# FINAL DRAINAGE PLAN AND REPORT

## HOT MIX HEIGHTS DEVELOPMENT

### AMENDED PLAT BARBARICK SUBDIVIISON

PCD File #  
PPR2332

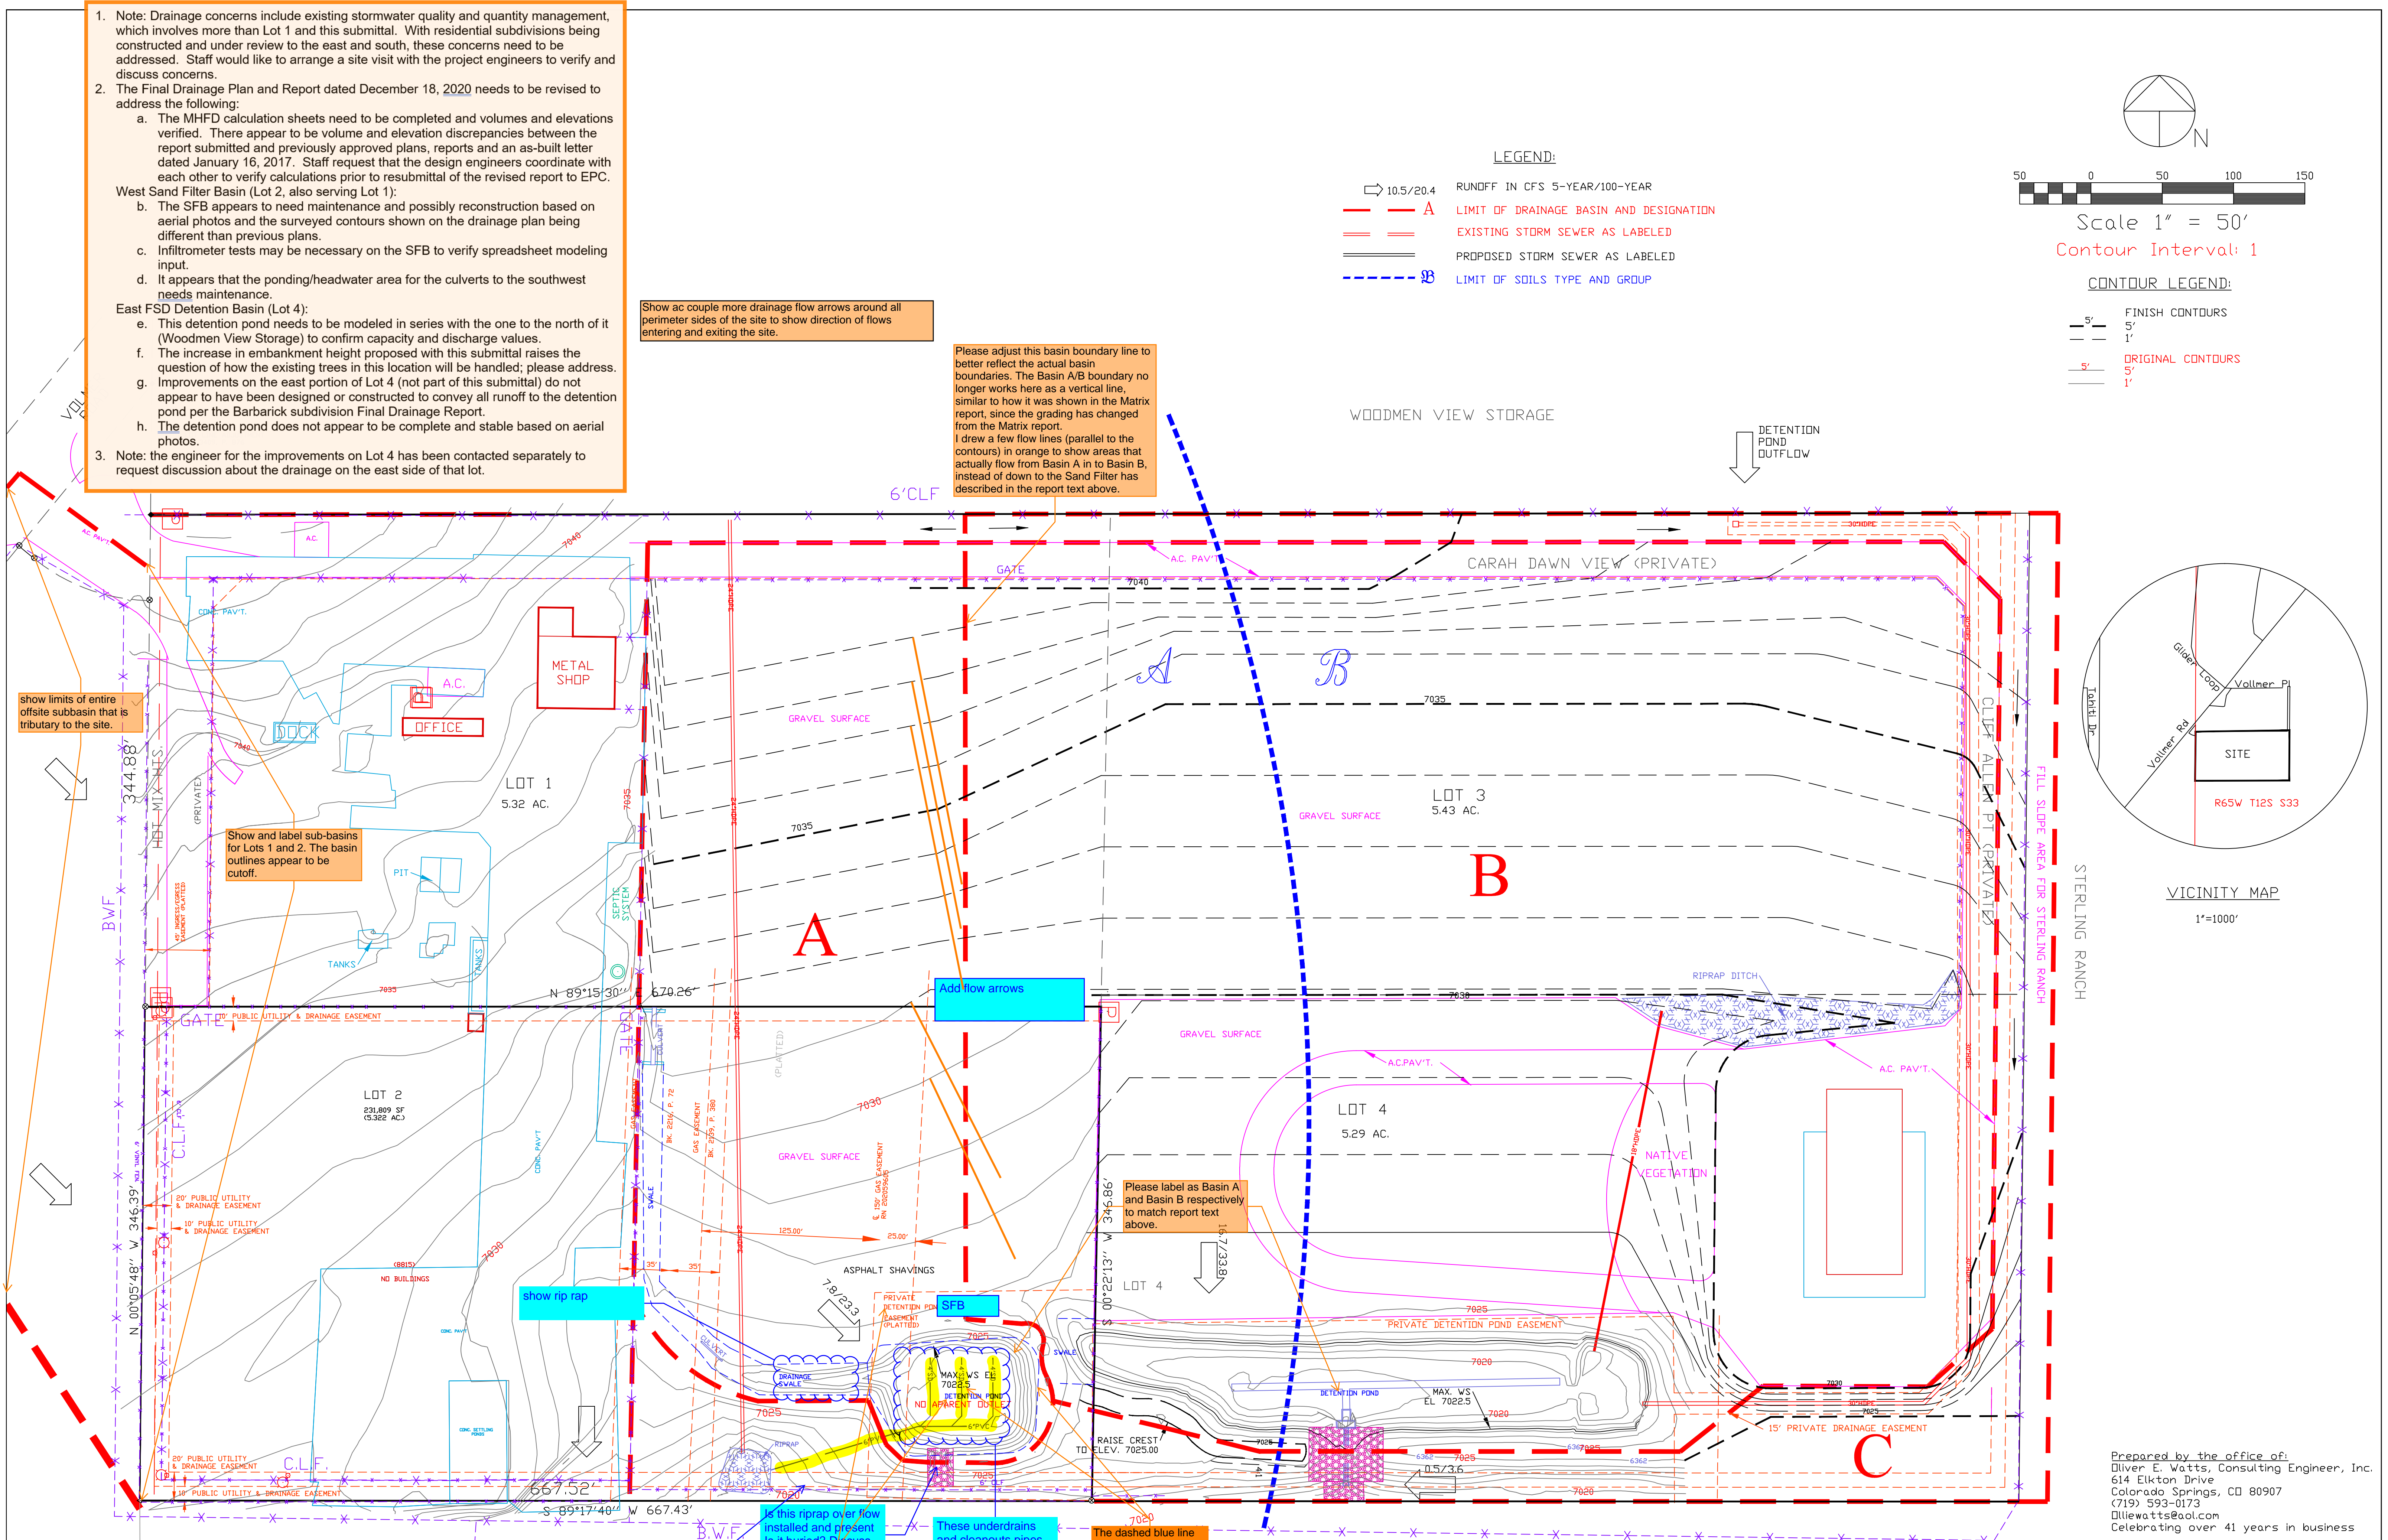
Show ac couple more drainage flow arrows around all perimeter sides of the site to show direction of flows entering and exiting the site.

Please adjust this basin boundary line to better reflect the actual basin boundaries. The Basin A/B boundary no longer works here as a vertical line, similar to how it was shown in the Matrix report, since the grading has changed from the Matrix report. I draw a few flow lines (parallel to the contours) in orange to show areas that actually flow from Basin A in to Basin B, instead of down to the Sand Filter as described in the report text above.

show limits of entire offsite subbasin that is tributary to the site.

Show and label sub-basins for Lots 1 and 2. The basin outlines appear to be cutoff.

Add flow arrows

show rip rap

Is this riprap over flow installed and present is it buried? Discuss in narrative.  
Revise label to "Sand Filter Basin" to match report text above.

The dashed blue line for Max WSEL should follow the 7022.5 contour. But as shown it crosses over multiple contour lines. Please revise.
